Thank you for the opportunity to review the public comment draft Remedial Investigation (RI) report for the Glacier Northwest Site (Glacier NW Site), which is located along the western shore of the Lower Duwamish Waterway (LDW), immediately north adjacent to the Port of Seattle's (Port) Terminal 115 (T-115). The T-115 property encompasses two MTCA cleanup sites – North Terminal 115 (T-115 North) and Terminal 115 Plant 1 (T-115 Plant 1)– both being addressed under separate Agreed Orders (AOs).

The Port is submitting the following comments on the Glacier NW Site draft RI report (draft RI). For Ecology's reference, figures that present arsenic and pentachlorophenol (PCP) occurrences in shallow and deep groundwater near the Glacier NW and T-115 property line, a cross section and a focused conceptual site model (CSM) that span the property line are attached to accompany our comments.

Cmt No.	RI Section	Statement in Draft RI	Port Comment
1	2.2	*Although Terminal 115 and North Terminal 115 are separate sites with individual MTCA orders (Order No. 18064 and Order No. 8099, respectively), the two sites will be referred to jointly as "T115" hereon.*	Refer to the two T-115 sites separately

FIGURE 1

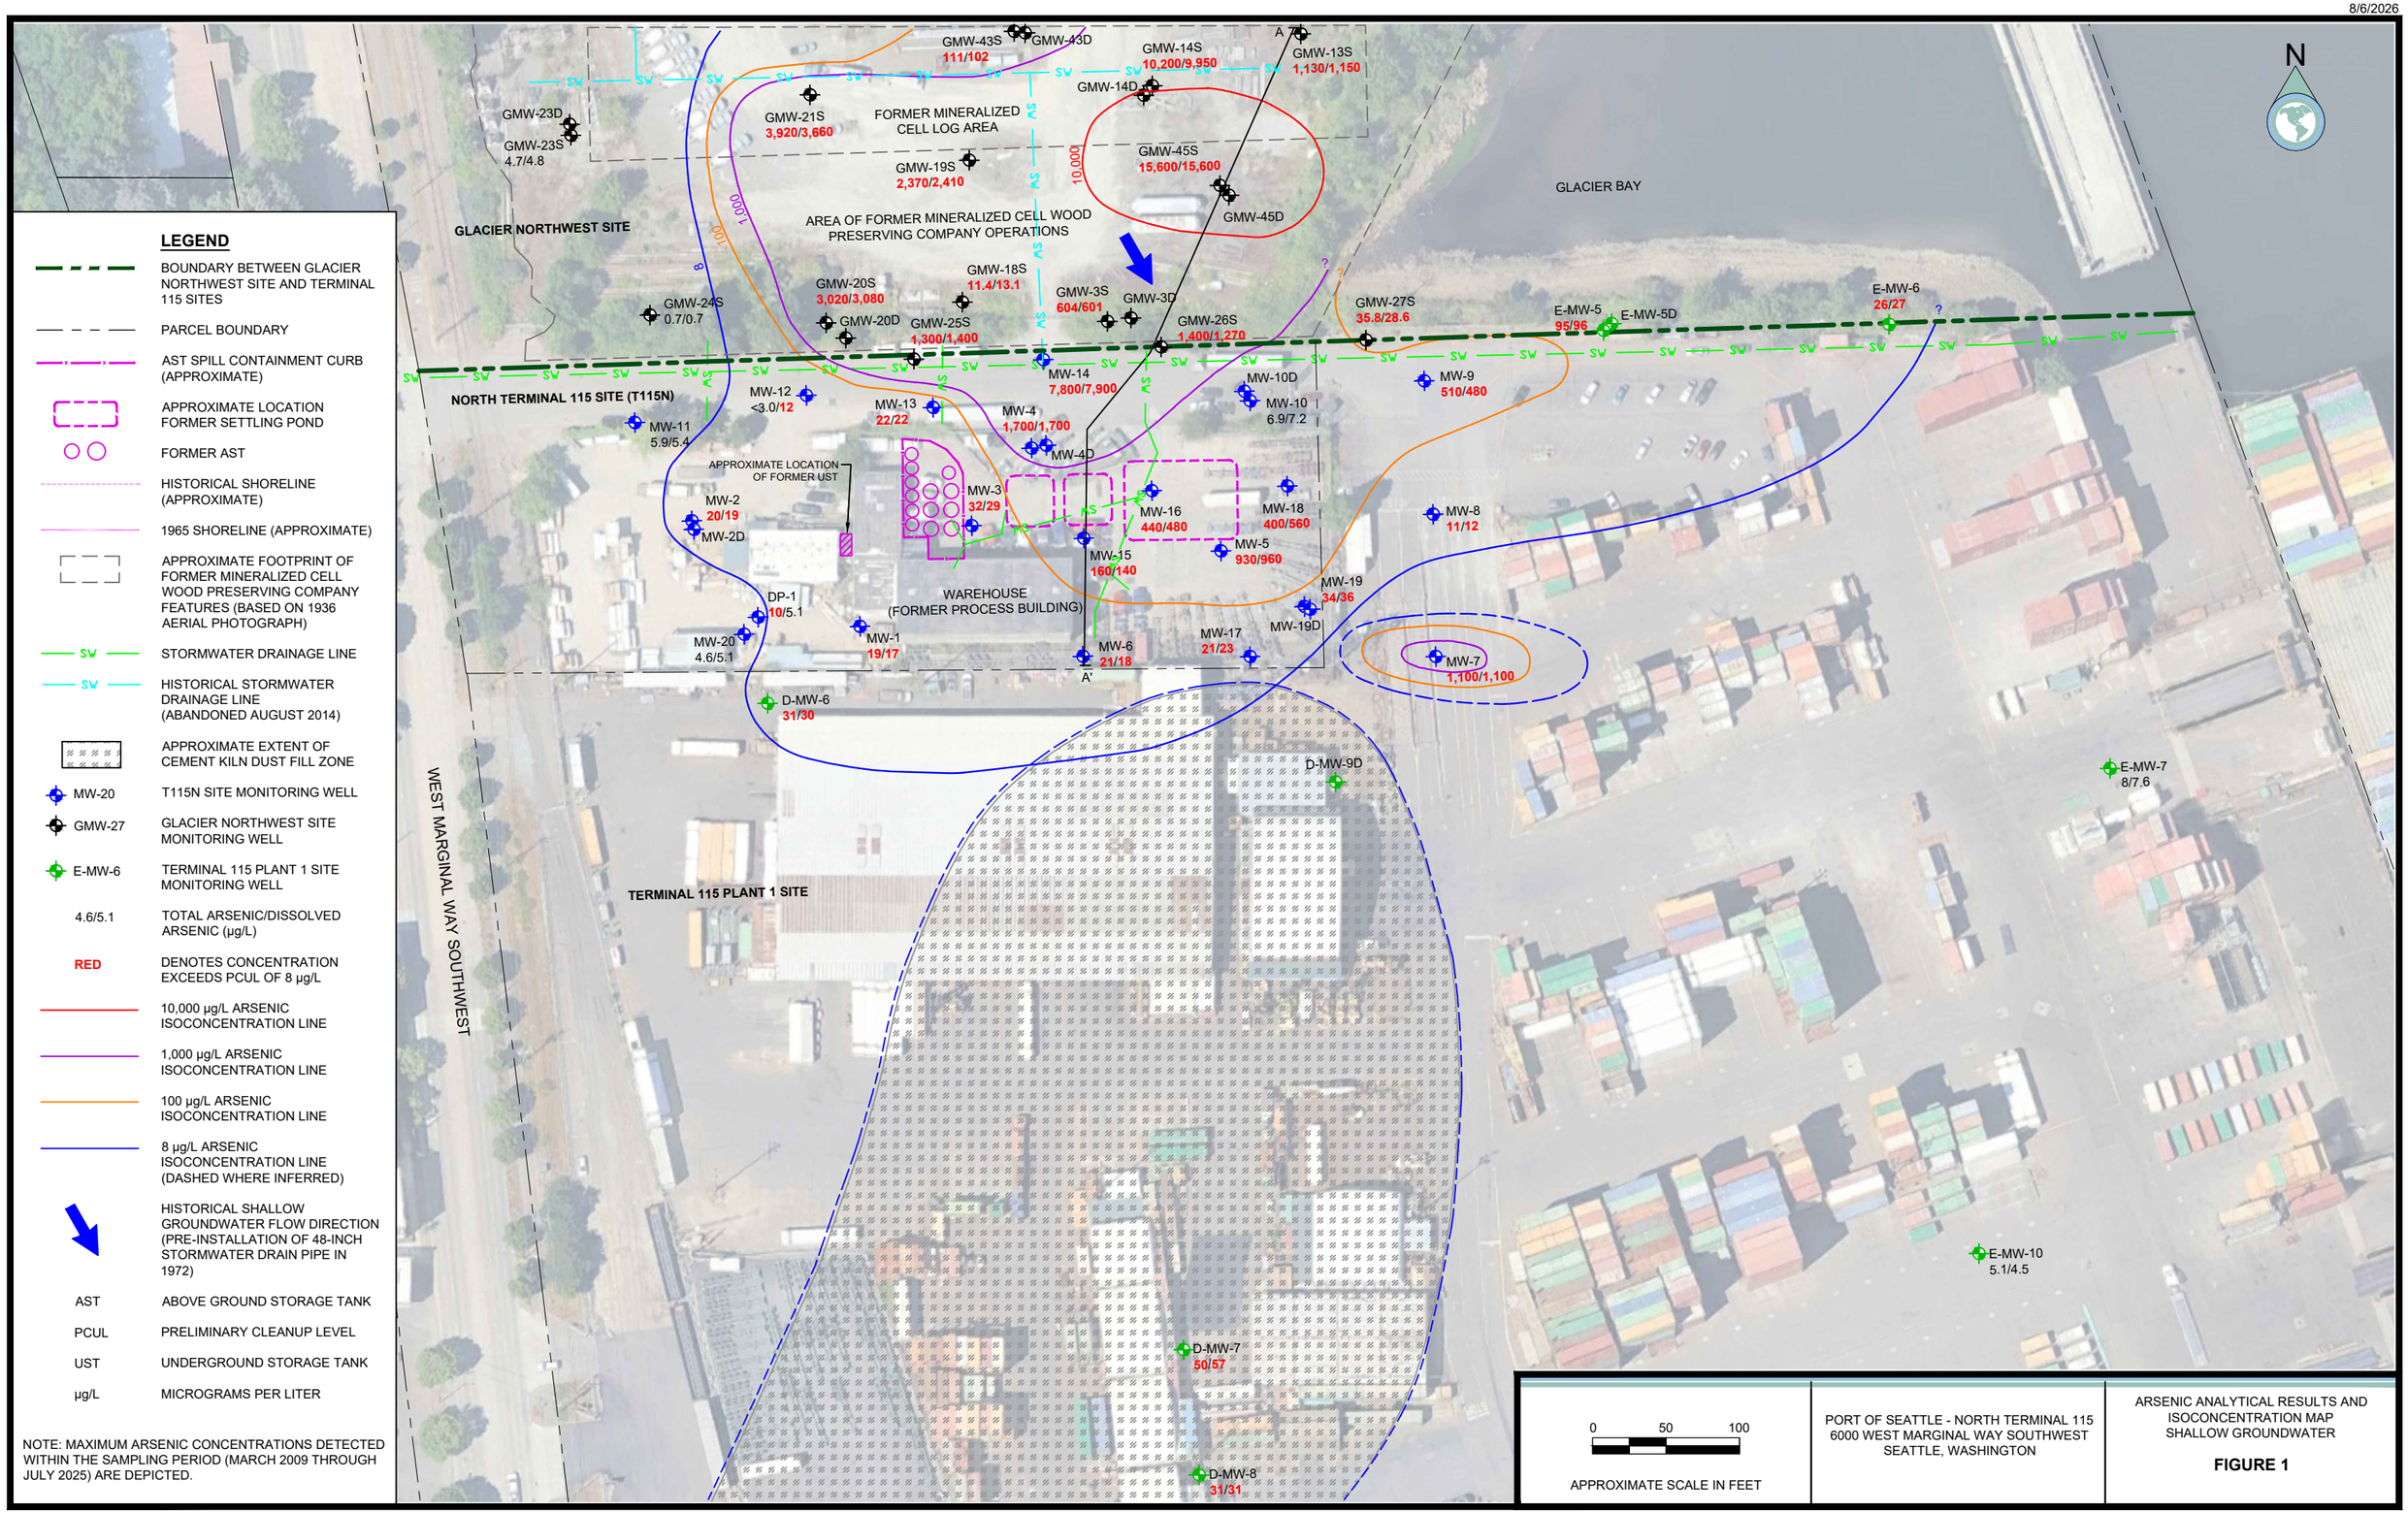
• Arsenic is a primary COPC for the Glacier NW Site present in groundwater at concentrations more than three orders of magnitude greater than the proposed CULs due to releases from former Mineralized Cell wood preservation operations conducted along the southern portion of the Glacier NW property between 1936 and 1939 (as described in Section 2.6.4 of the draft RI). Section 5.2.1.1 of the draft RI states "on the Port of Seattle property, arsenic in groundwater exceeding the SL [screening level] is laterally delineated to the east and west, but not to the south." This statement acknowledges that the arsenic plume from the Glacier NW Site has migrated onto Port property.
			  ○ Figure 5-12 of the draft RI shows arsenic in shallow groundwater on T-115 property at concentrations greater than the SLs (term used as surrogate for proposed CUL as proposed CULs are not defined in the draft RI), which shows that arsenic in groundwater has migrated south from the Glacier NW site onto the T-115 property. These findings are consistent with data collected as part of separate RIs conducted for both the T-115 North and the T-115 Plant 1 cleanup sites (see attached arsenic figures).

FIGURE 4

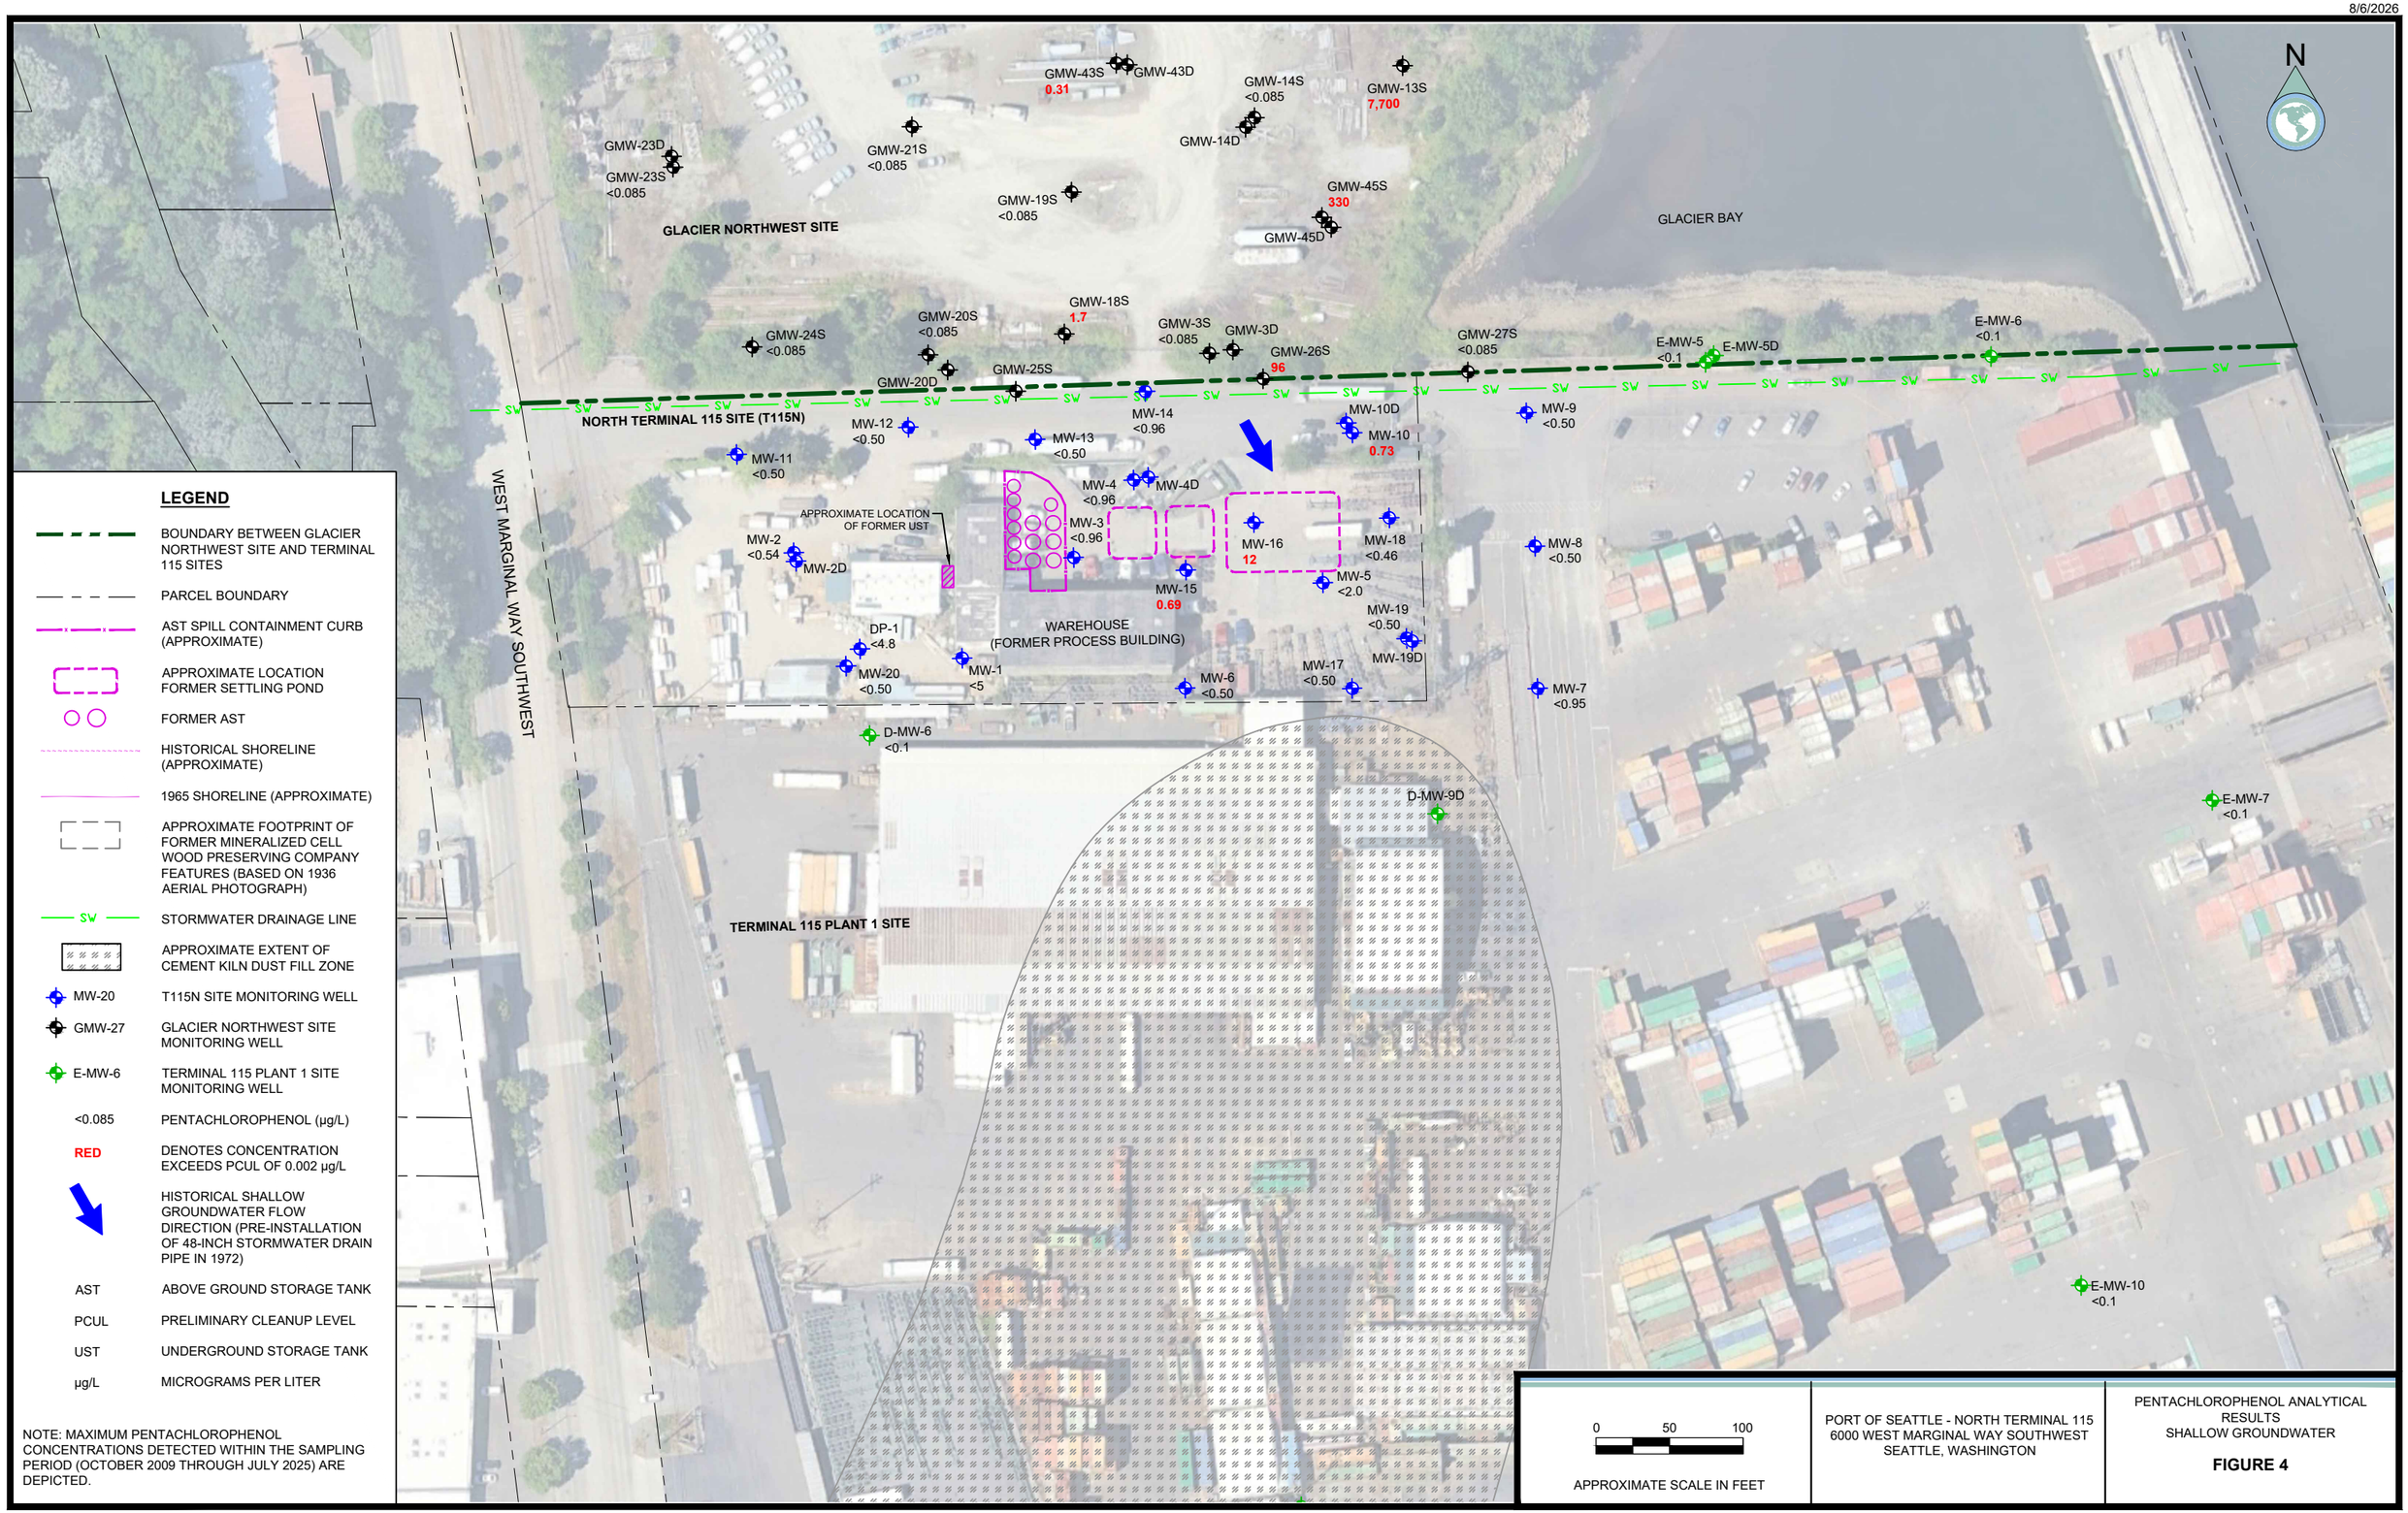
• Similarly, PCP is present at concentrations greater than SLs in shallow groundwater on the T-115 North Site, which likely originated from former Reichold operations on the Glacier NW property from 1946 to 1961 (Section 2.6.6 of the draft RI). PCP concentrations in shallow groundwater on the Glacier NW property are generally one or more orders of magnitude higher than PCP concentrations detected on the T-115 North Site.
			  ○ Section 5.2.4.1 of the draft RI states: "PCP SL exceedances occur in shallow groundwater on the Port of Seattle property in monitoring wells MW-15, MW-16, and MW-10, and are bounded by monitoring wells MW-4, MW-3, MW-6,
